Regulatory Compliance Report

Compass 2 Warehouse & Distribution Centre
Lot 1 Eastern Creek Drive, Eastern Creek

Prepared for: Charter Hall
Date: 11.02.2022
Revision: D

Figure 1 - Required width for vehicular access

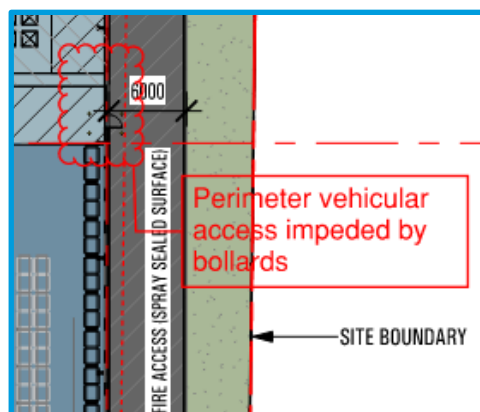
Perimeter vehicular access to the northern and eastern sides of Warehouse impeded by bollards required to protect egress doors (refer to **Figure 1**). According to C2.4, the required vehicular access must have a minimum unobstructed width of 6 m. Please provide a new design or confirm if a Performance Solution approach will be taken for the project.

Figure 2 - Vehicular access to the building more than 18m

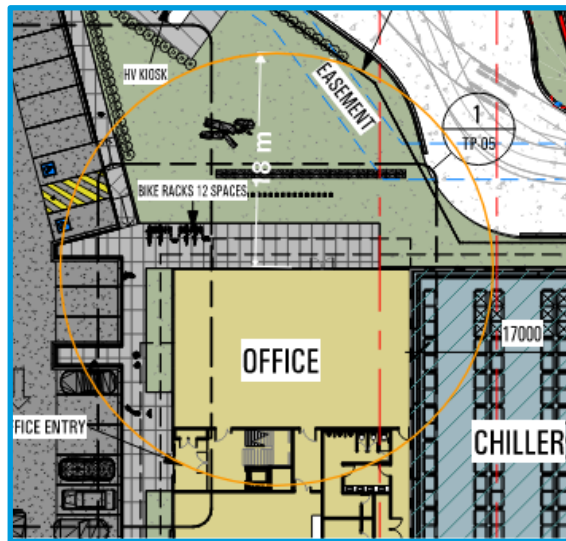
Perimeter emergency vehicular access must be within 18m of the entire building perimeter in accordance with BCA CI C2.4. The access to the South Western corner of the site is more than 18m from the building (refer to **Figure 2**)

Figure 3 - Extended travel exit in the warehouse

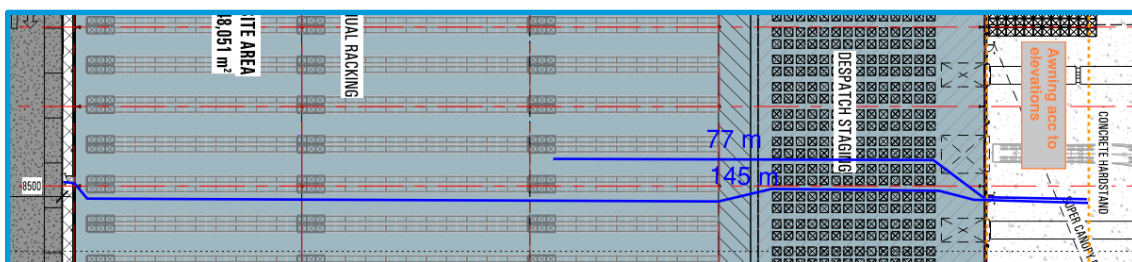
- Travel distances in the warehouse exceed the maximum 40m distance requirement and distance between alternative exits exceeds the maximum 60m requirement of BCA when measuring to outside of the awnings (refer to **Figure 3**)

The extended travel distances need to be addressed to comply with the requirements of the deemed to satisfy provisions noted above or be assessed as performance solutions by the Fire Safety Engineer using BCA Performance Requirements DP4 & EP2.2

Figure 4 - Extended travel distance in main office first floor

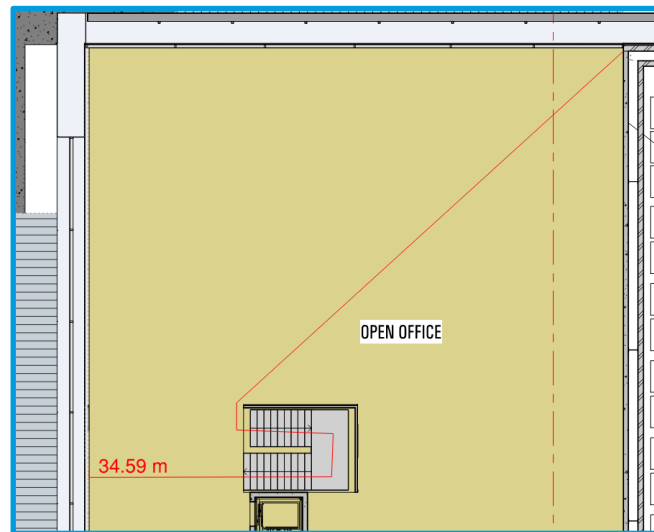
- Travel distance in the main office first floor exceeds the maximum 20m distance requirement of BCA (refer to **Figure 4**)

Figure 5 - Swing doors

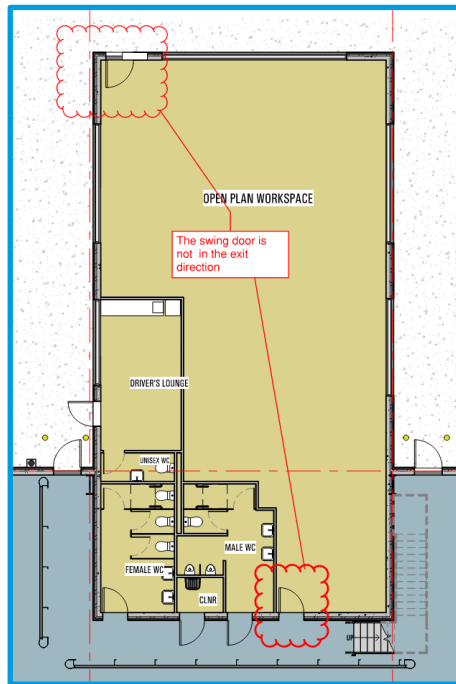
The exit doors of the Dock office ground floor open inward (refer to **Figure 5**). According to CI D2.20(b), a swinging door in a required exit or forming part of a required exit must swing in the direction of egress.

A reviewed design or Performance solution required for further assessment.

Figure 6 - The toilet doors have the WCs within 1200mm

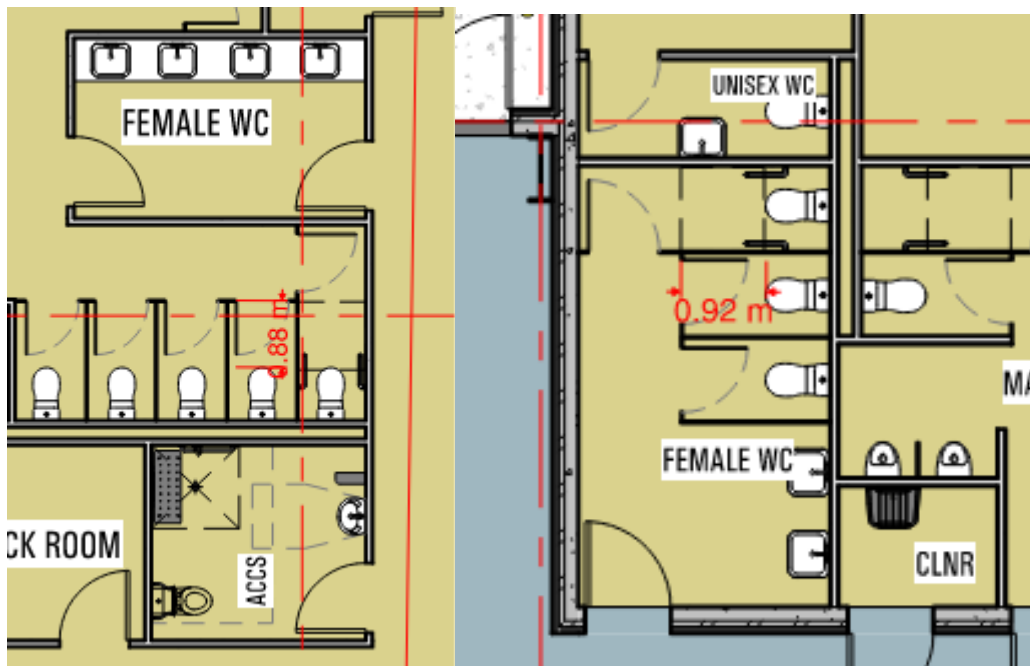
The bathroom doors in the offices have the WC within 1200mm. The doors must be opened outward or equipped with removable hinges unless the design is updated (refer to **Figure 6**).
